Modern robotics device detection problems

Peter Brier

FTC Brabant

January 2016

12V and 5V measurement on core module

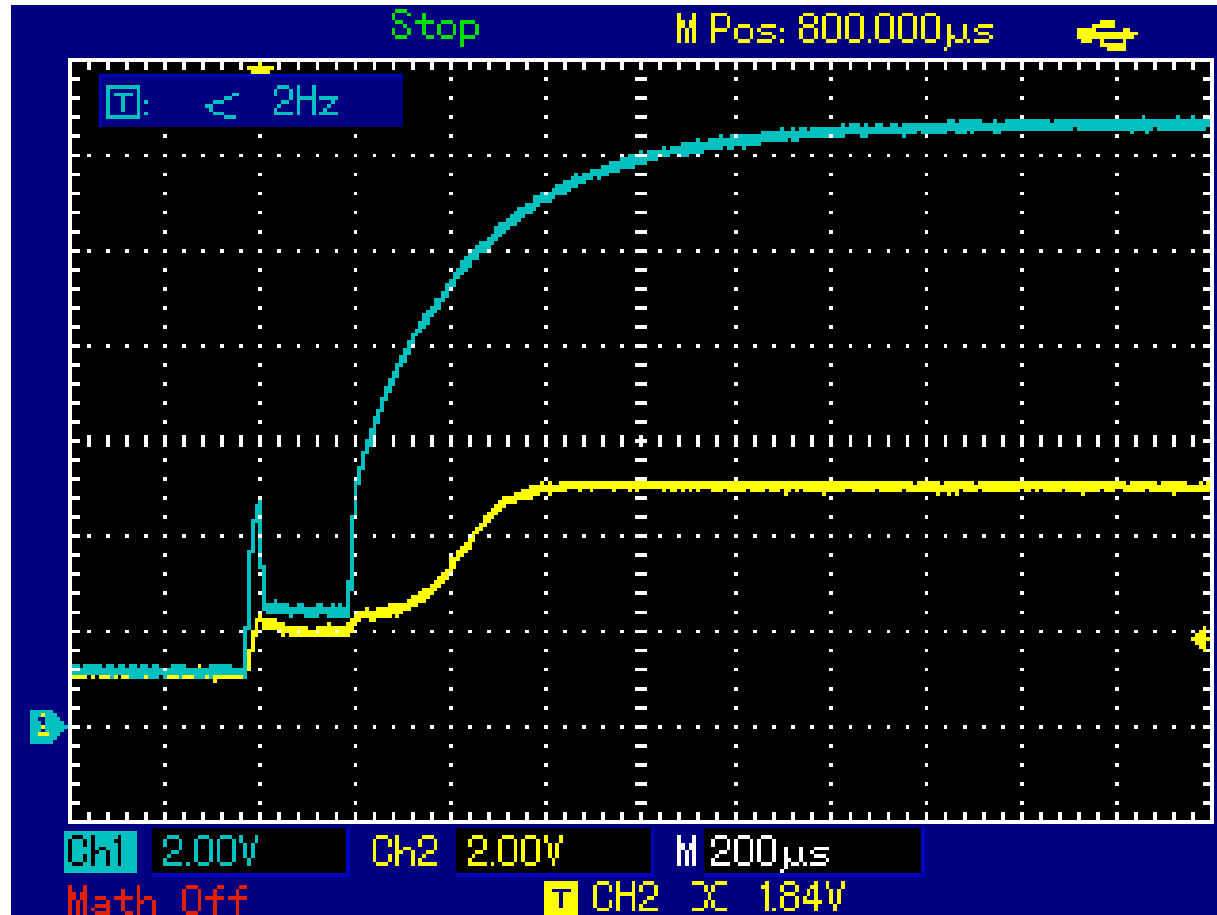
Slow rise of 12V with plateau

5V takes 600usec to stabilize

Initial voltage not zero
(due to remaining charge in capacitors)

Note: Takes > 20 seconds to fully drain
capacitors in this setup

5V and RESET voltage measurement on PIC

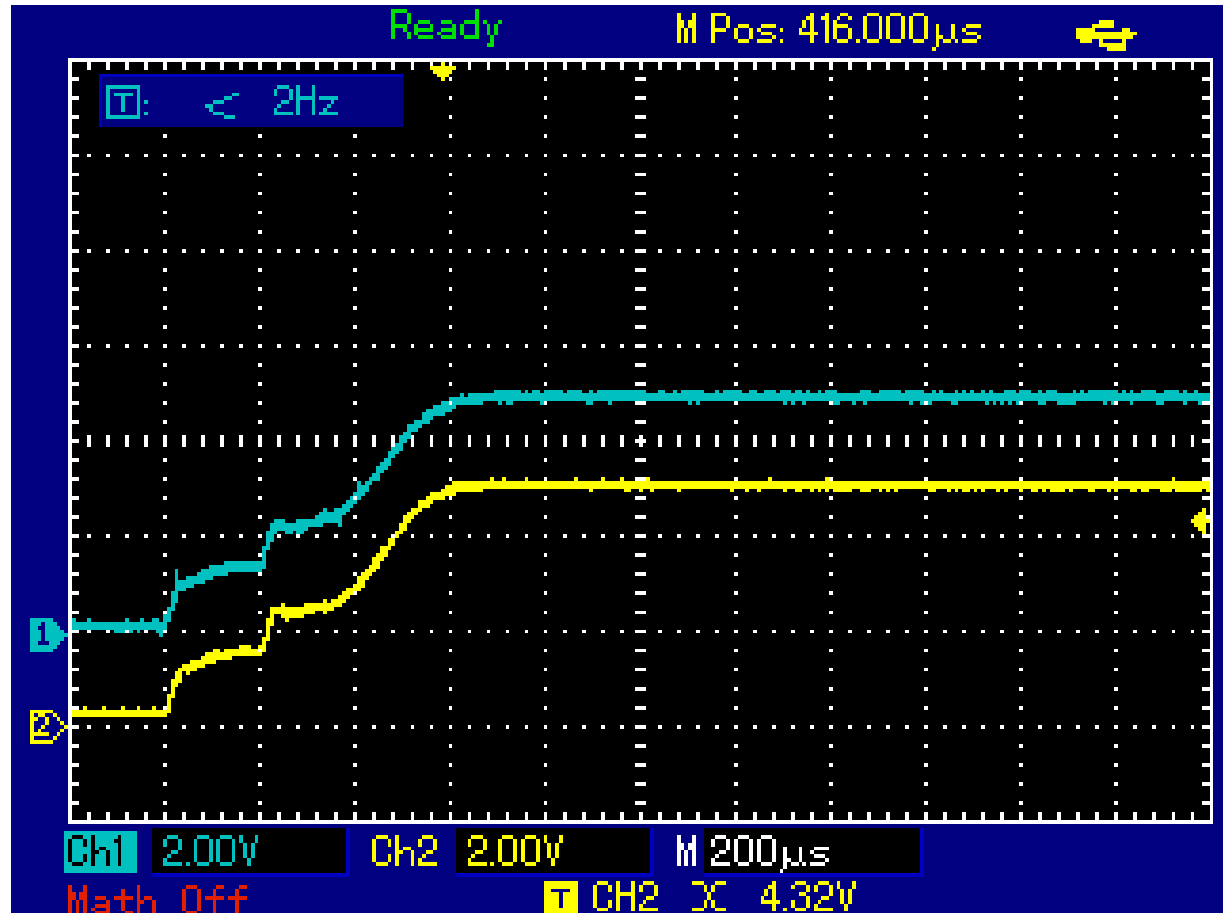
No delay in reset line!

Reset connected to 5V via $R=100\text{k}\Omega$

No capacitor

(datasheet suggests $500\ \Omega < R < 10\text{k}\Omega$)

Is the 64msec power up reset timer active?

If not: can cause problems at reset!

Actual circuit used in Core Module
R=100kOhm

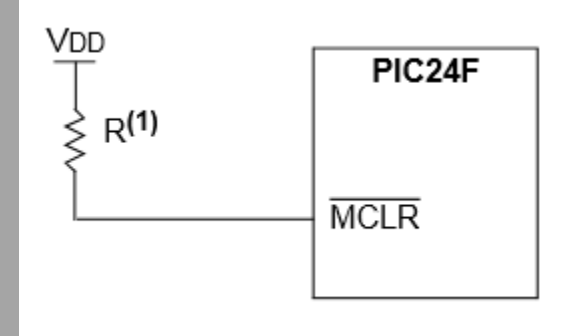
(docs suggest: R=500..10k)

Program/Debug connector

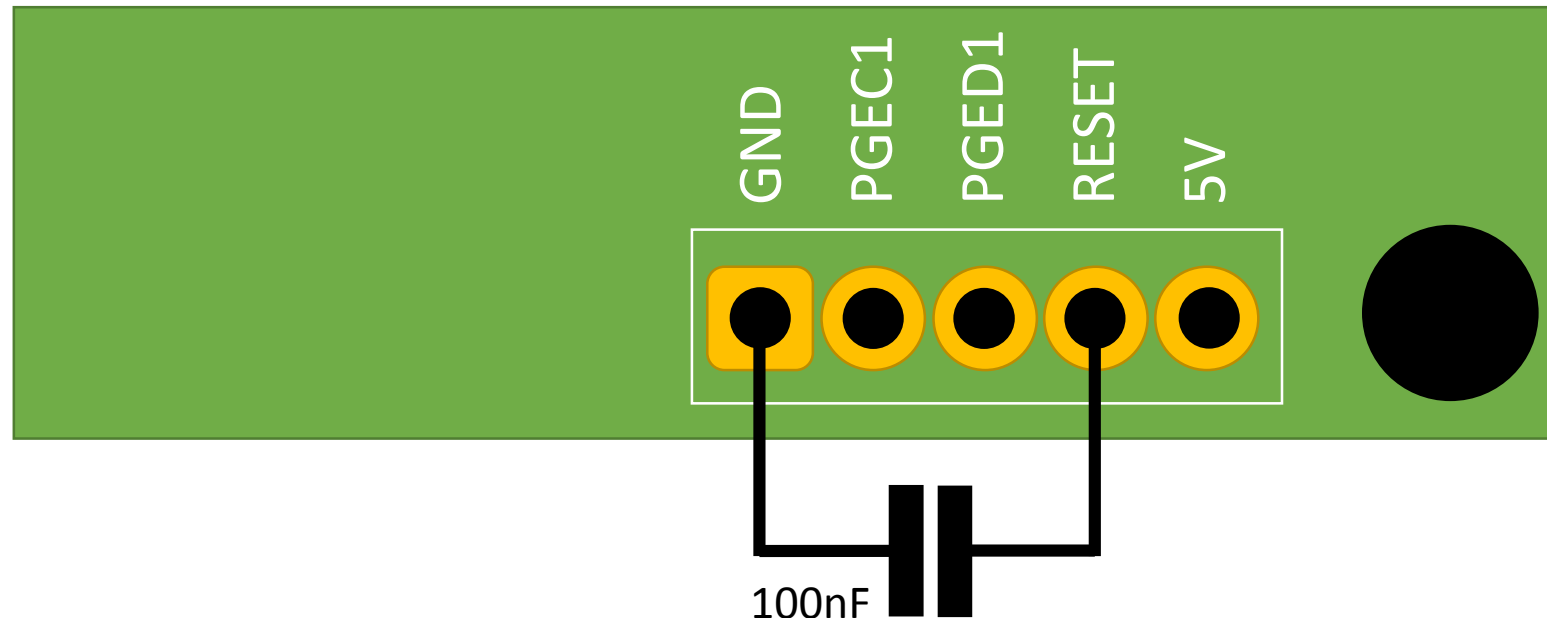
- Located on Code module PCB
- Add 100nF Capacitor to delay rise of reset signal
- Note: may also prevent possible CM reset due to static

12V and RESET voltage measurement on PIC

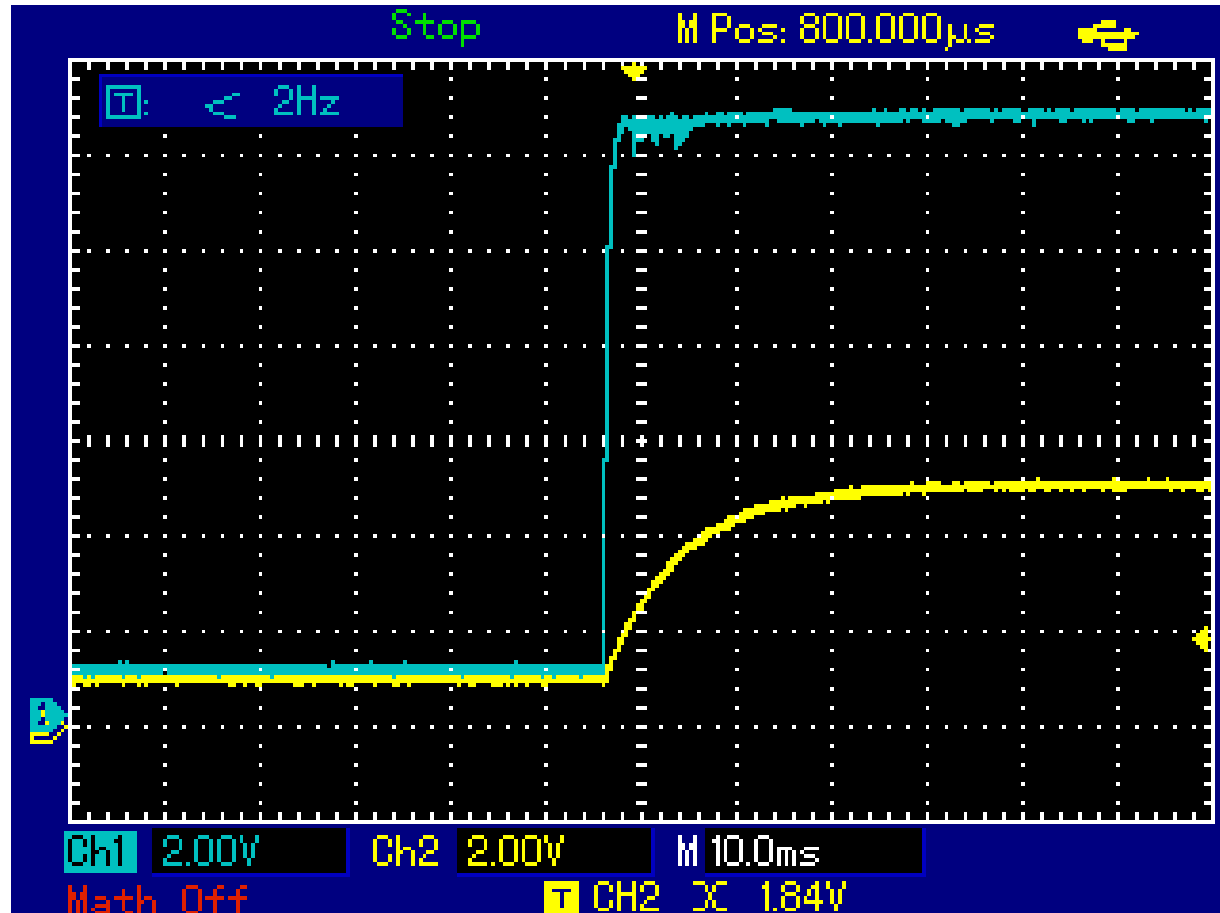
Delay in reset line ~ 30msec

Switch on-detection problems solved
for the patched modules
